PATENTS ACT 1977

APPLICANT Dr Harry Nduka

ISSUE Whether patent application GB0818371.7 complies with sections 1(1)(a), 14(5)(b),(c) and 76(2) of the Patents Act 1977

DECISION

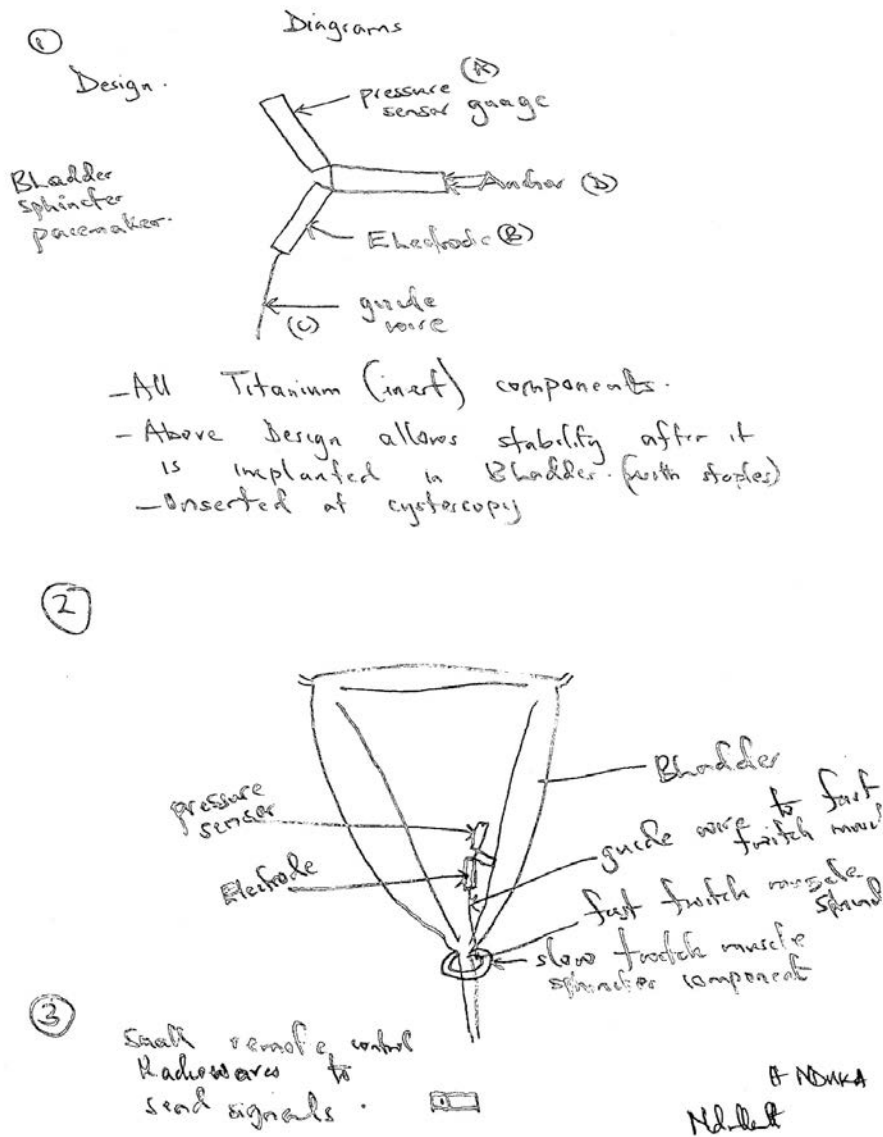
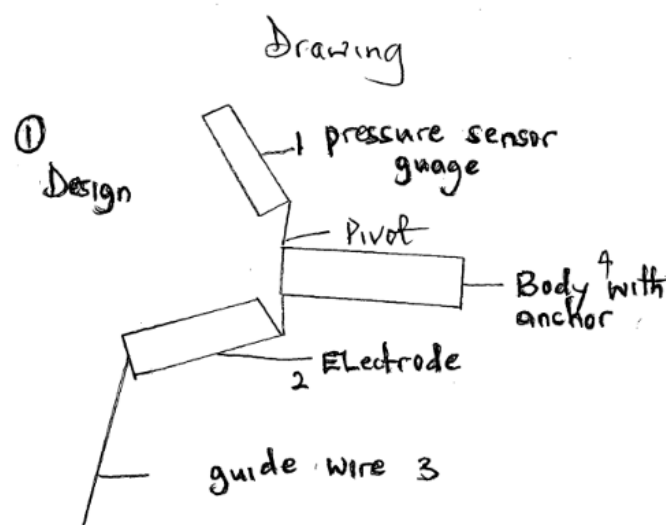
- 21 The page of new formal drawings labelled '1 Design' discloses two drawings, one drawing with the device outside and one drawing with the device inside the bladder. These two drawings generally correspond to the original informal drawings 1 and 2. Original drawing 1 discloses that the sensor arm and the electrode arm directly abut against the anchor arm, however, the new formal drawings show the sensor arm and electrode arm are each separated from the body by an intervening element that is denoted by a line. This intervening element was not present in the original drawings and is considered to add matter. The same could be said for the intervening elements in the other new formal drawings.

②. Drawing, Diagrams

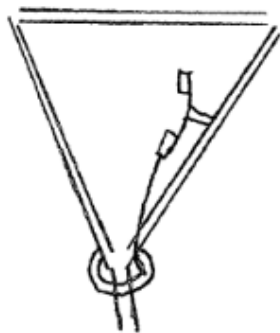
- 22 There are also new formal drawings on the page labelled '2 Drawing, Diagrams'. These were not present in the originally filed drawings and show the device to have both 'Y' and 'T' shaped formations within the bladder. As the originally filed drawings show the device having a 'T' shape when in the bladder and a 'Y' shape when outside the bladder this is also adds matter.

- 23 These are differences between the originally filed drawings and new formal drawings which I find add matter under section 76 of the Act. They do not properly accord as directed by Mr Wyand, and are not allowable.
